Tioga Inn Viewshed

SECTION 1 REVIEW OF ALTERNATIVE 6 AND ALTERNATIVE #7-HYBRID PLAN IMPACTS ON AESTHETIC RESOURCES

Revised Determinations regarding Aesthetic Impacts of Alternative #6

One Story and Two Story Housing

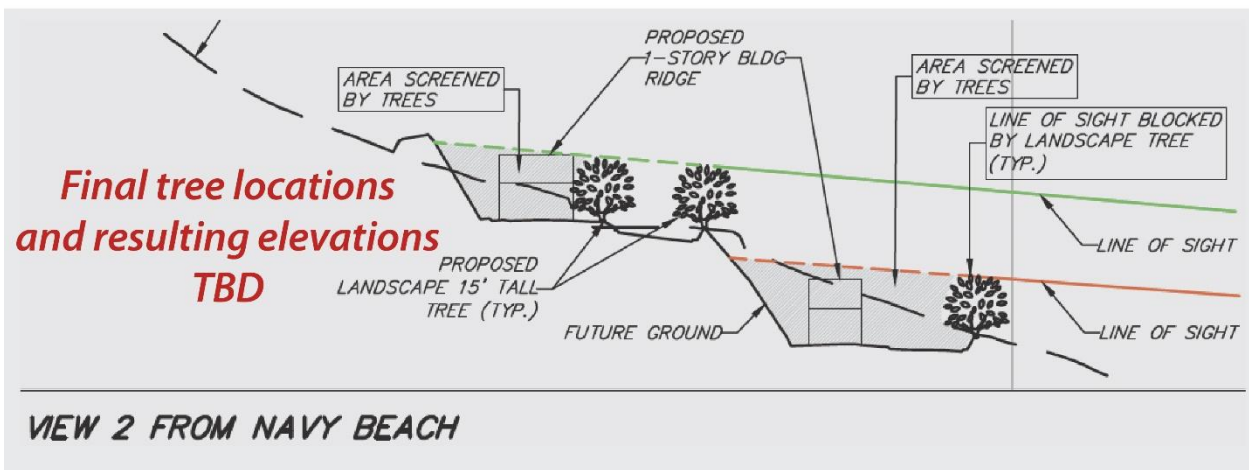
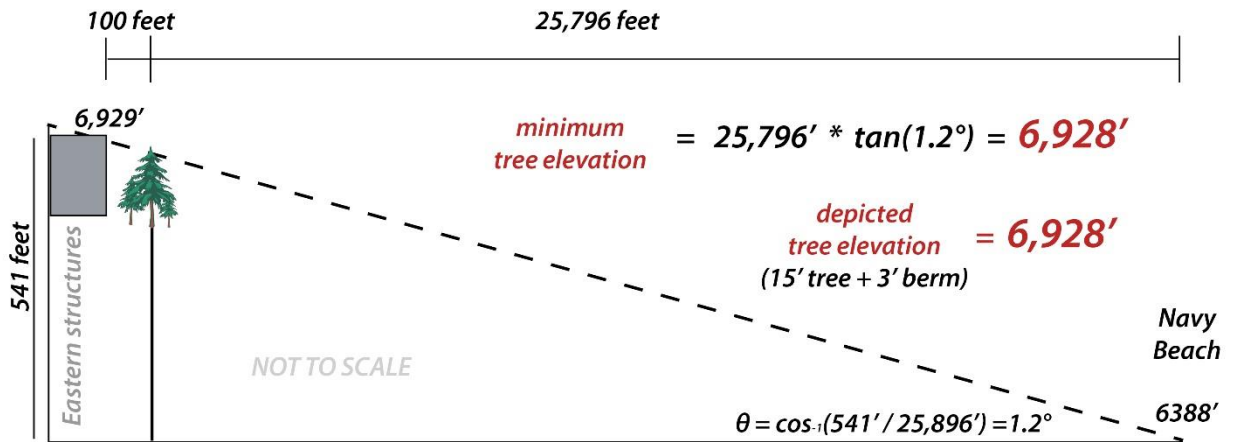
The Final Subsequent EIR/Updated Draft Subsequent EIR (FSEIR/DSEIR) dated June 2020 presented information and conclusions about the visual impact of Alternative #6 that have been determined to be incomplete. In particular, the June FSEIR/DSEIR presented inaccurate conclusions that plan revisions associated with Alternative #6 would limit offsite views from Navy and South Tufa beaches to the upper story of the five westernmost two-story buildings with no offsite exposure of the easternmost single-story structures.

The project engineers subsequently determined that the original Alternative #6 sight line studies were incorrectly scaled, resulting in a vertical distortion that led to the incorrect conclusions above. Once the distortion was corrected, the project engineers concluded that approximately 6-8 feet (6 feet of roofing and up to 2 feet of siding) of virtually all of the one-story structures on the easternmost row in Alternative 6 would have been visible from South Tufa Beach and Navy Beach. The project engineers noted, and it is herein acknowledged, that the sight line studies are subject to margins of error associated with the distance studied (roughly five miles) and digital elevation models used to map the sight lines and visibility cones. This margin of error also applies to the sight line and visibility cones prepared for Alternative #7-Hybrid Plan.

VIEW 2 FROM NAVY BEACH

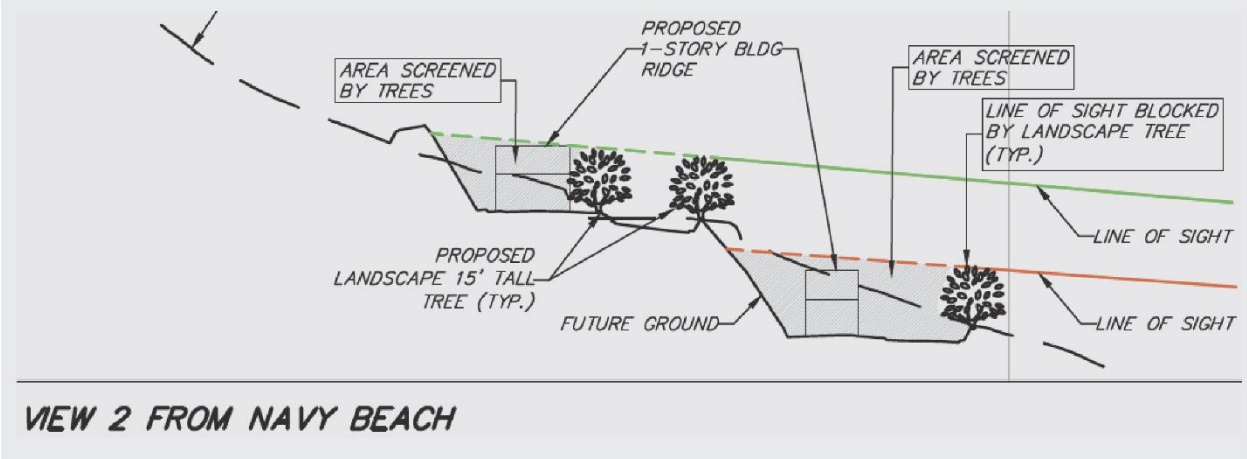
**Unobstructed Sight Line to
 Navy Beach Parking Lot**

“Sight line studies are subject to [unquantified] margins of error”
